**REMARKS**

SERIAL # -  
TITLE: THRU-THICKNESS FIBER-  
REINFORCED, RESIN-TRANSFER-  
MOLDED, COMPOSITE FAN-BLADE  
INVENTOR: BRUCE G. BUSBEY, et al.  
DOCKET: 13DV-13367-2  
ATTY: NATE HERKAMP  
PHONE: (513) 243-6473-  
- SHEET 1 OF 3 -

FIBER REINFORCED  
COMPOSITE ARTICLE

FIG. 1

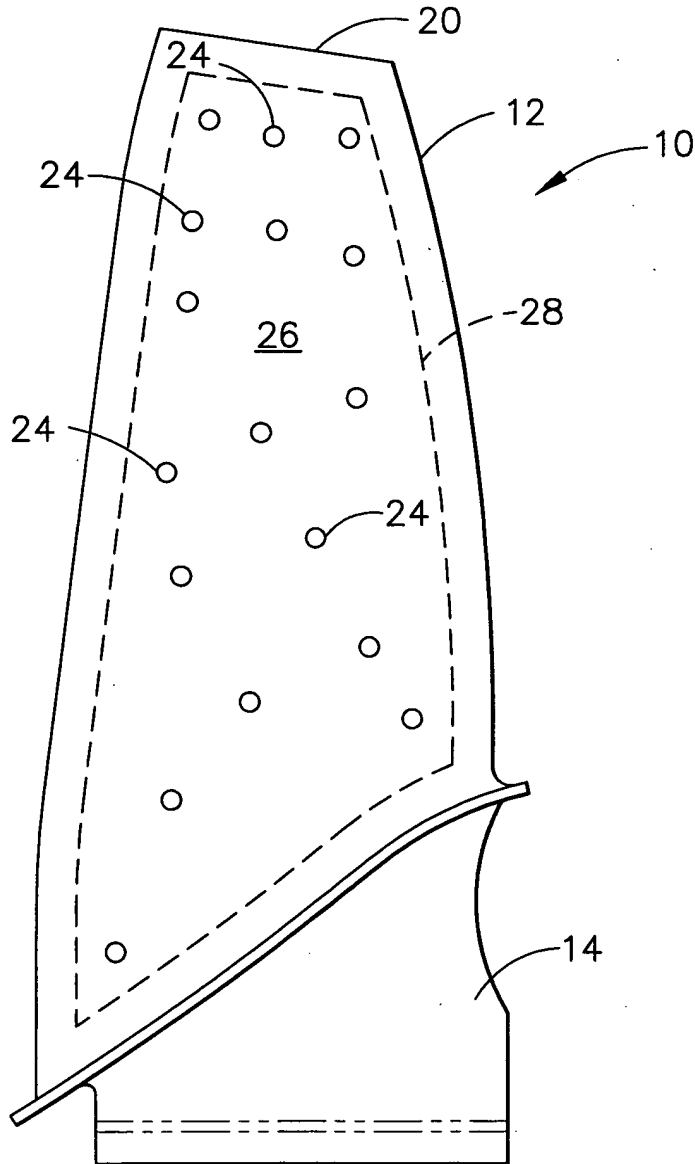
Attached hereto as an Appendix are “Annotated Marked-up Drawings” showing in red changes made to original sheets 1, 2 and 3 of the drawings.

FIBER REINFORCED  
COMPOSITE ARTICLE  
JACK W. BALDWIN et al.  
WILLIAM SCOTT ANDRES  
5955

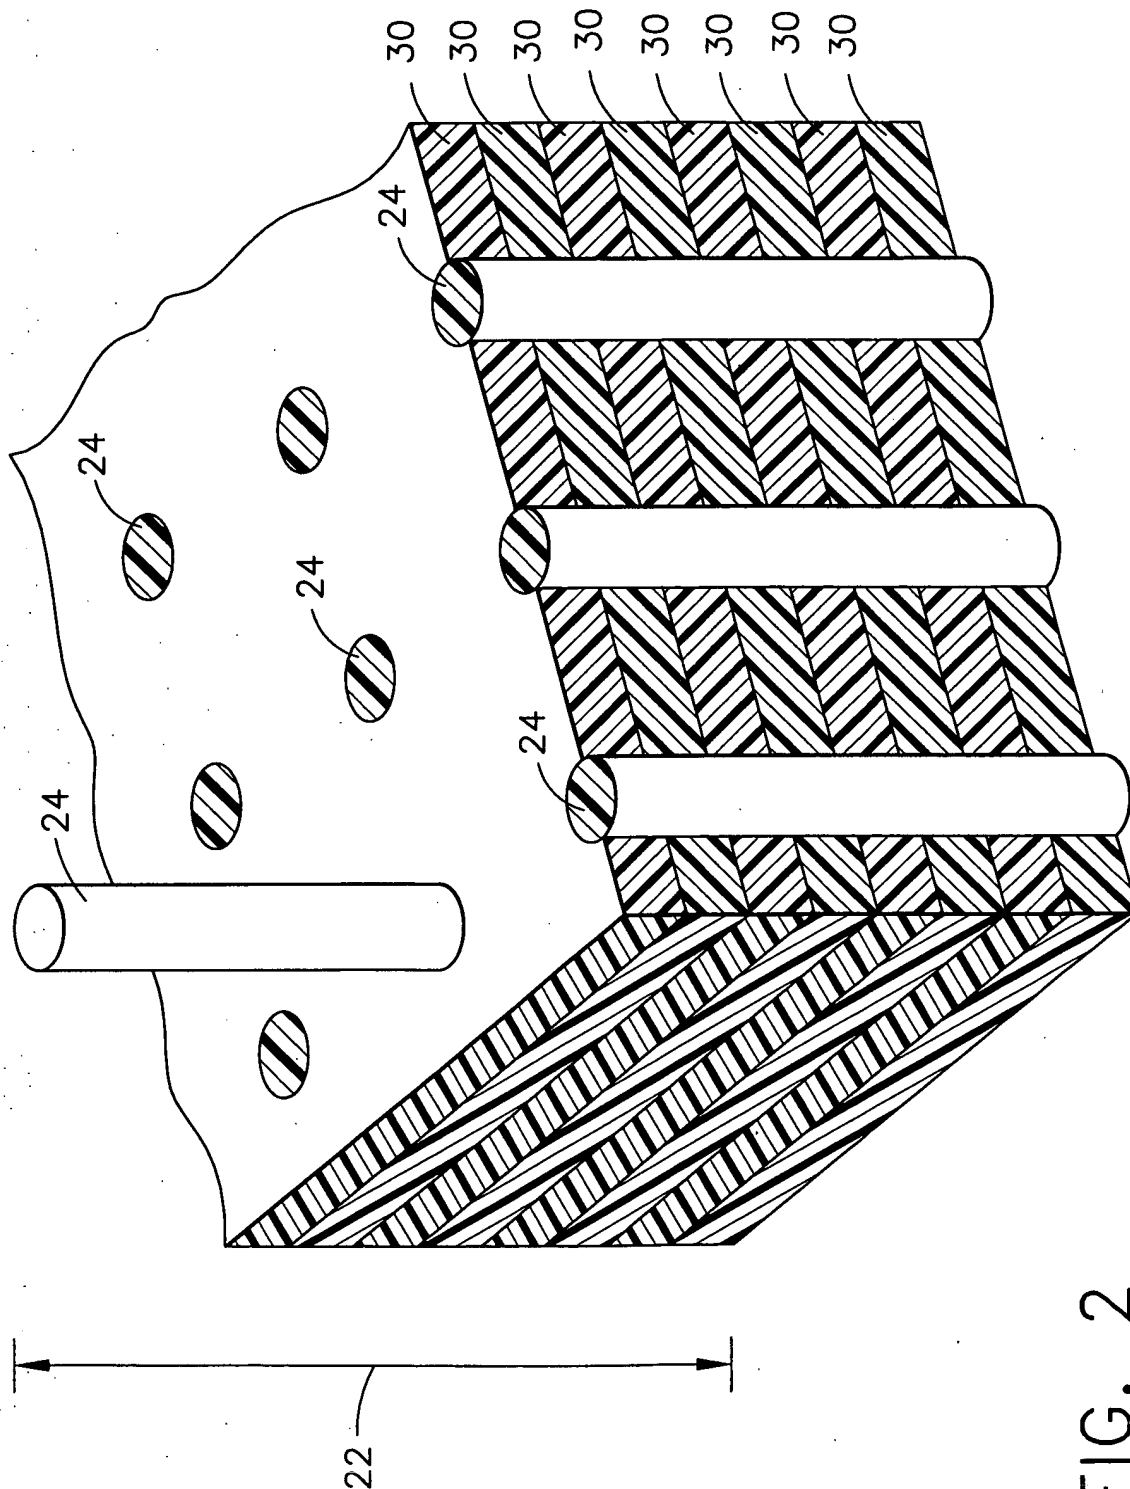
SERIAL #  
TITLE: THRU THE THICKNESS FIBER  
REINFORCED, RESIN TRANSFER  
MOLDED, COMPOSITE FAN BLADE  
INVENTOR: BRUCE C. BUSBEY, et al.  
DOCKET: 13DV-13367-2  
ATTY: NATE HERKAMP  
PHONE: (513) 243-6473  
SHEET 2 OF 3
